SUBJECT: DAVIS-BESSE NUCLEAR POWER STATION, UNIT NO. 1 - ISSUANCE OF
AMENDMENT RELATED TO STEAM GENERATOR INVENTORY CHANGE
(TAC NO. MF0536)(L-13-040)

DAVIS-BESSE NUCLEAR POWER STATION, UNIT NO. 1

Amendment No. 287
License No. NPF-3

SAFETY EVALUATION BY THE OFFICE OF NUCLEAR REACTOR REGULATION
RELATED TO AMENDMENT NO. 287 TO FACILITY OPERATING LICENSE NO. NPF-3
FIRSTENERGY NUCLEAR OPERATING COMPANY
FIRSTENERGY NUCLEAR GENERATION CORP.
DAVIS-BESSE NUCLEAR POWER STATION, UNIT NO. 1
DOCKET NO. 50-346

Figure 3.7.18-1 (page 1 of 1)
Maximum Allowable Steam Generator Level

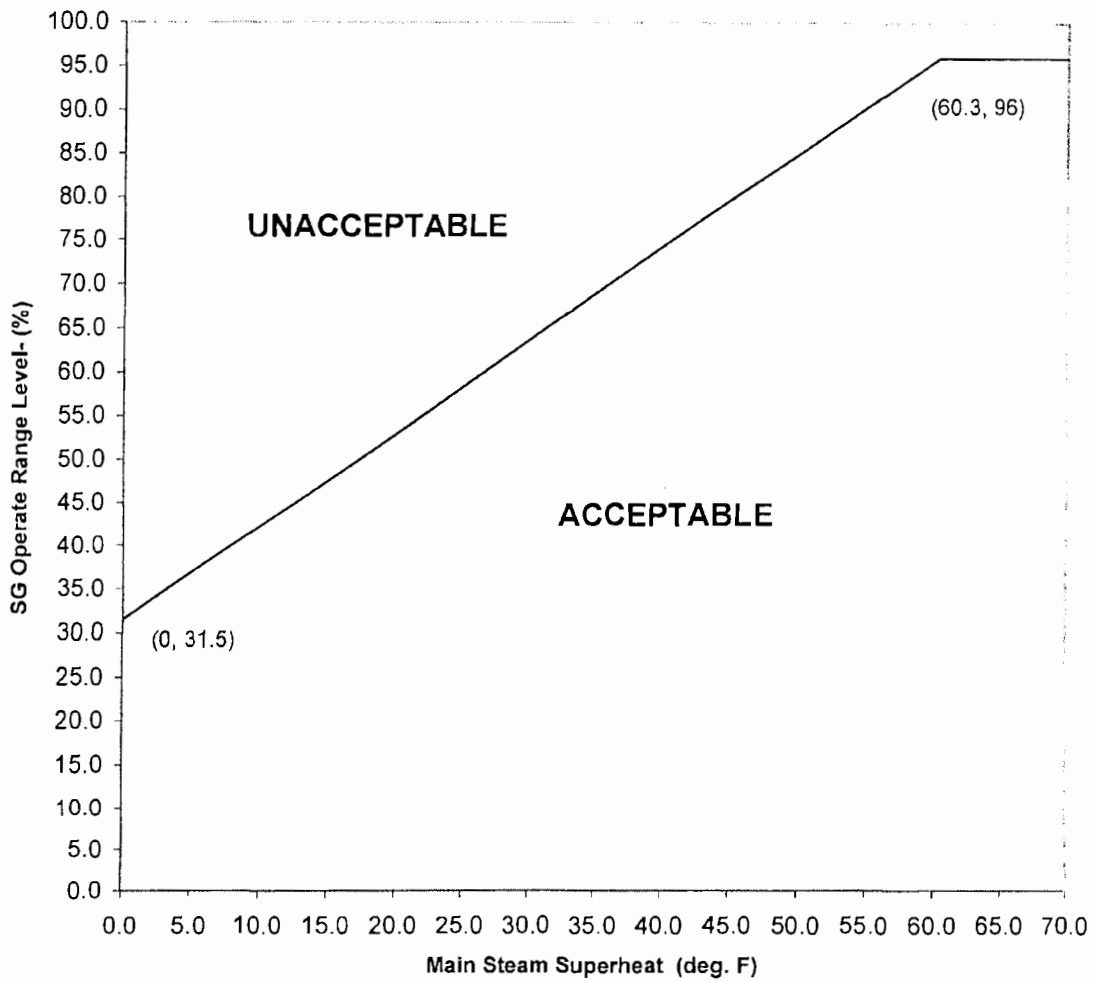
TS 3.7.18, "Steam Generator Level," establishes limit on SG level based on operating MODE and plant operating conditions. The four restrictions currently established in LCO 3.7.18 are based on the specific physical design characteristics and dimensions of the original SGs. Because of differences in design characteristics and dimensions of the replacement SGs, TS 3.7.18 would be revised to ensure appropriate secondary-side inventory limits are imposed. Specifically, LCO 3.7.18.a provides the maximum SG level allowed in MODE 1 or 2, by reference to TS Figure 3.7.18-1, "Maximum Allowable Steam Generator Level." Figure 3.7.18-1 identified acceptable Steam Generator Operate Range level indication (in percent) as a function of steam superheat [in degrees Fahrenheit (°F)]. Because of secondary-side dimensional and thermal performance differences between the original and replacement SGs, current TS Figure 3.7.18-1 is not appropriate for use with the replacement SGs and is to be replaced. Replacement Figure 3.7.18-1 was developed using the same

In its January 18, 2013, submittal, the licensee stated that TS Figure 3.7.18-1 provides a curve of SG level as a function of main steam superheat. The licensee stated that the proposed new curve, which reflects the dimensional characteristics and thermal performance differences of the new SGs, was obtained via the same methodology as the existing curve. The licensee also stated that given the proposed curve, the existing UFSAR MSLB analysis remains bounding.

methodology used for the original, with the supporting analyses based on the dimensions and thermal performance of the replacement SGs.

In its supplemental letter dated September 27, 2013, the licensee provided additional information about the methodology used to develop the new LCO curve. The licensee stated that the curve was developed using a computer code that solves for the steady-state conditions in once-through SGs. The code, VAGEN, predicts the steam superheat produced for a given SG mass inventory. The same computer code had been used for the previous curve; however, a newer version was used to develop the proposed curve. The licensee also stated that the newer version was validated using plant data, and that the validation indicated that the newer version more accurately simulated existing plant conditions than the previous.

Since the licensee used the same code to determine the proposed LCO as that used to determine the previous LCO, and since the updated version of VAGEN was validated and showed better agreement with plant data, the NRC staff determined that the LCO, which prescribes SG operate range level as a function of steam superheat, continues to ensure that the maximum SG liquid inventory assumed in the MSLB analyses is bounding of the design characteristics of the replacement SG. Based on this consideration, the NRC staff concluded that the proposed LCO is acceptable. Since the existing analysis remains bounding of plant operation with the new SGs, the NRC staff determined that the applicable design criteria, relating to adequate reactivity control, RCBP integrity, and adequate core cooling, remain satisfied in accordance with the current licensing basis.
